CITY OF HOOD RIVER

STAFF REPORT QUASI-JUDICIAL SITE PLAN REVIEW

RE: File No. 2019-22 - Major Adjustment to Site Plan Review Permit File No. 2007-53

A. **REQUEST:** Modification of an existing Site Plan Review Permit for Verizon Wireless affecting wireless communication facilities located on the penthouse of the Hood River County Administration Building. The proposal features replacement of three cylinders that are used to screen wireless antennas with a 10-foot-tall by 12-foot-wide by 12-foot-long screen wall, as well as to replace and relocate associated wireless communication facilities. A total of nine panel antennas are proposed to be located inside the screen wall. (*See Attachment "A.1"*, *Preliminary Plan Set.*)

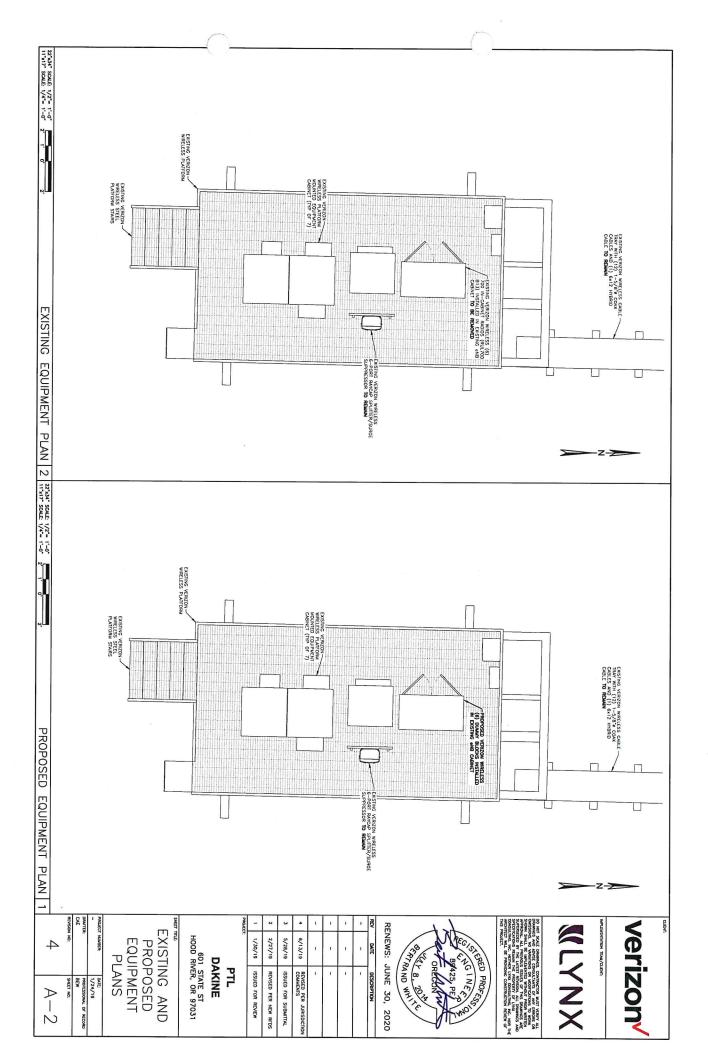
The proposed screening wall is not expected be used for human occupancy but, as depicted in the Preliminary Plan Set (Attachment "A.1", Sheet A-1) it does include a door to facilitate human access. The planning commission is asked to determine whether the screening wall is a "vertical projection" subject to these provisions or if it is part of the County Administration Building structure and therefore subject to the building height limitations of the C-2 Zone.

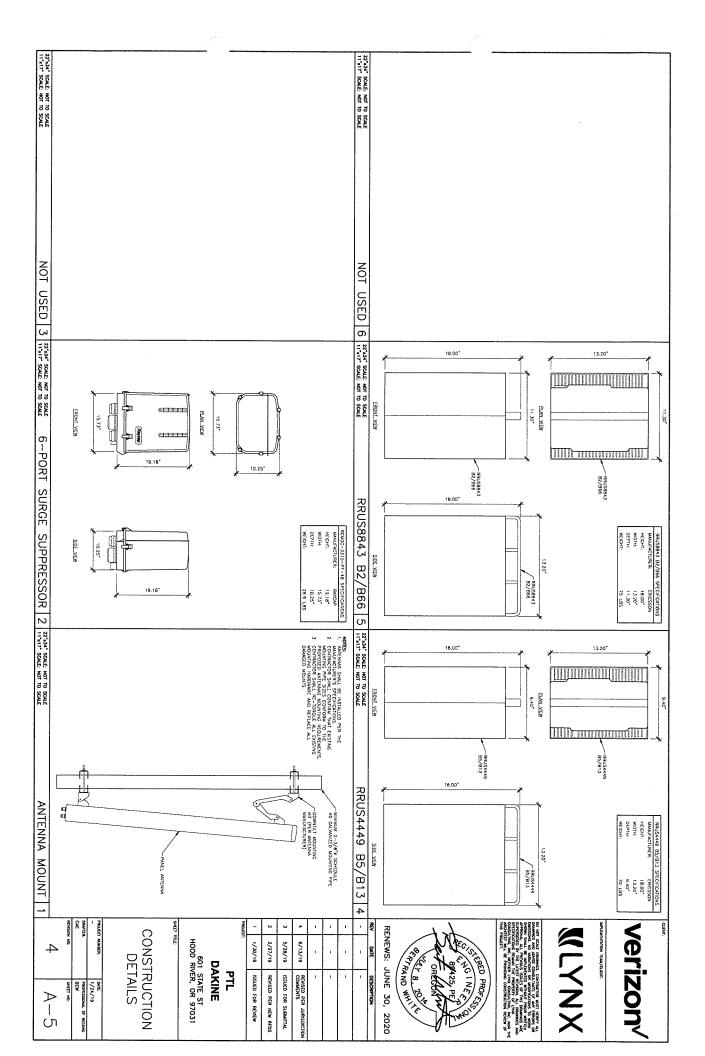
FINDINGS: Sheet A-3 of the Preliminary Plan Set (Attachment "A.1") indicates the existing penthouse has a top elevation of 48 feet 5 inches, and Sheet A-4 indicates the proposed screening wall has a top elevation of 58 feet 5 inches tall. Both measurements were taken from finish grade on the north side of the building.

The proposed equipment is not expected to generate noticeable noise, thus no sound buffer is required. However, it is not clear that that design attention has been given to effectively screen equipment from view. As depicted on Sheet A-4 of the Preliminary Plan Set (Attachment "A.1"), the proposed screening wall has a top elevation nearly 20 feet above the parapet that surrounds the building's main roof. Further, its location near the northeastern corner of the roof of the penthouse appears to be the highest possible position on the building relative to street and sidewalk elevations thereby increasing its visibility. As such the proposal is not found to comply with this criterion.

As depicted on Sheet A-4 of the Preliminary Plan Set (Attachment "A.1"), the top of the parapet wall surrounding the building's main roof is at an elevation approximately 38'6" above sidewalk grade, and the top of the penthouse is approximately 48'5" above the same sidewalk elevation. The proposed screening wall has a top elevation of approximately 58'5" above this sidewalk elevation. No information was provided by the applicant to demonstrate buildings in the surrounding area have a similar height to the top elevation of the proposed screening wall.

It is not clear that the height or bulk of the proposed screening wall are compatible with the site or buildings in the surrounding area. As such the proposal is not found to comply with this criterion.
